**TOWN OF NEWBURGH
PLANNING BOARD
TECHNICAL REVIEW COMMENTS**

PROJECT: G & M ORANGE AMENDED SITE PLAN
PROJECT NO.: 14-22
PROJECT LOCATION: SECTION 95, BLOCK 1, LOT 73
PROJECT REPRESENTATIVE: M. A. DAY ENGINEERING
REVIEW DATE: 11 DECEMBER 2014
MEETING DATE: 18 DECEMBER 2014

Re: G & M Orange, LLC
95 Judson Road
Town of Montgomery
Orange County, New York

M.A. Day Engineering, PC Consulting Engineers	
3 Van Wyck Lane Westbury, NY 11591 (516) 334-1302	License No. 016646
G & M Orange, LLC Engineering, New York	
Utility Plan	
DATE: 12-11-11	SCALE: AS SHOWN
PROJECT: 400	NO. 840
UP.1

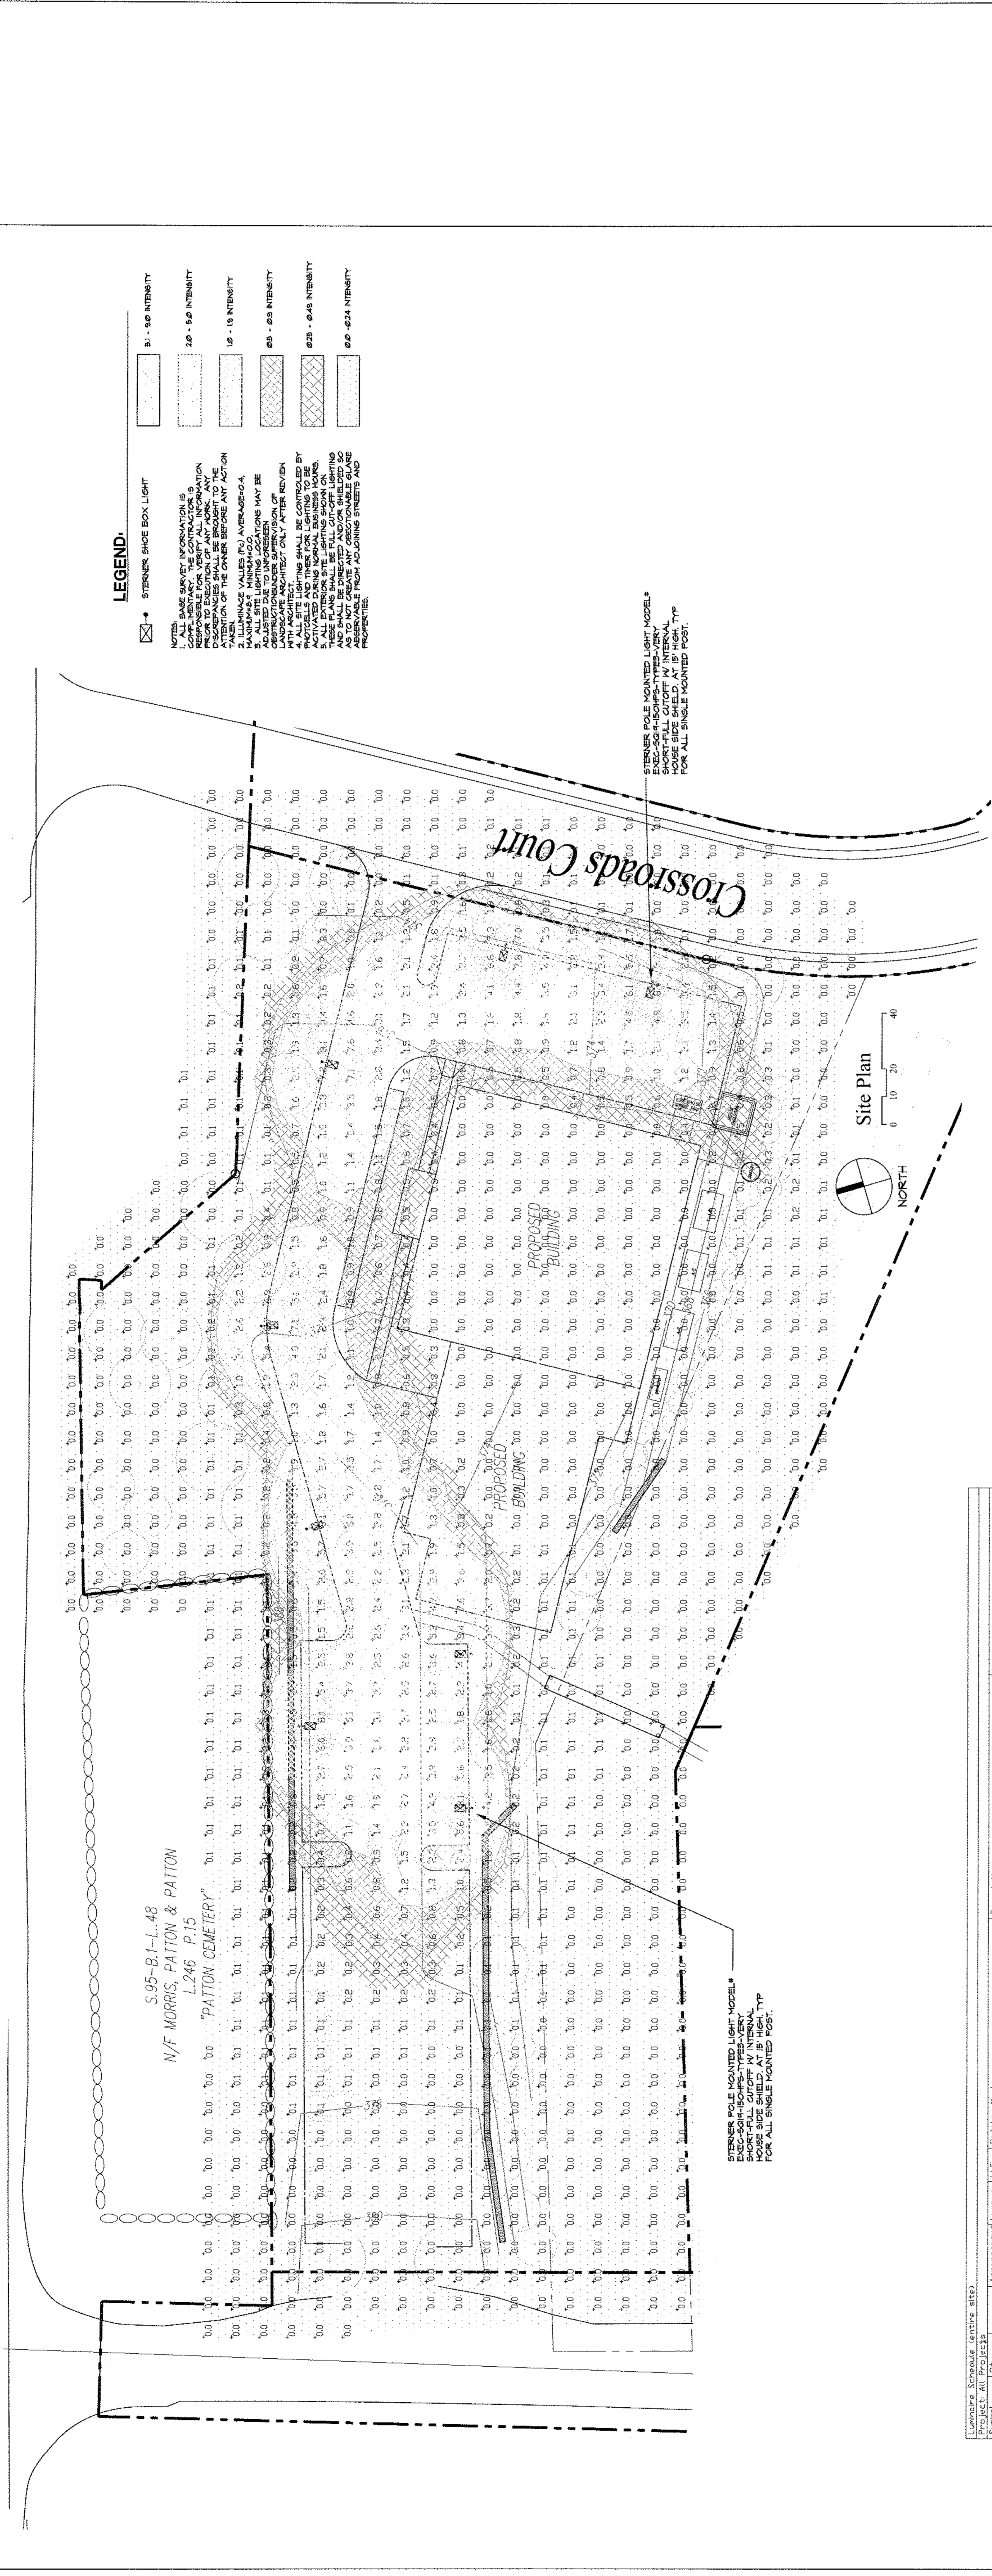
4. City of Newburgh Flow Acceptance letter should be received and are updated based on increased building square footage.
5. A revised storm water prevention plan has been provided to address the increase in impervious service for the amended site plan. Storm water management will be undertaken on the site through the use of an infiltrator system under the paved parking areas. An extensive infiltration system has been designed to allow all storm water run-offs to infiltrate into the site. No surface run off from the site will occur based on the infiltrator design.

1. Comment noted. Please see revised narrative.
2. The stormwater management plan has been updated to account for the additional impervious surfaces.
3. The emergency access off of Orr Avenue has been revised to 20' wide. Details for the proposed pavers and gate are shown on sheet DT.2.
4. Comment noted.
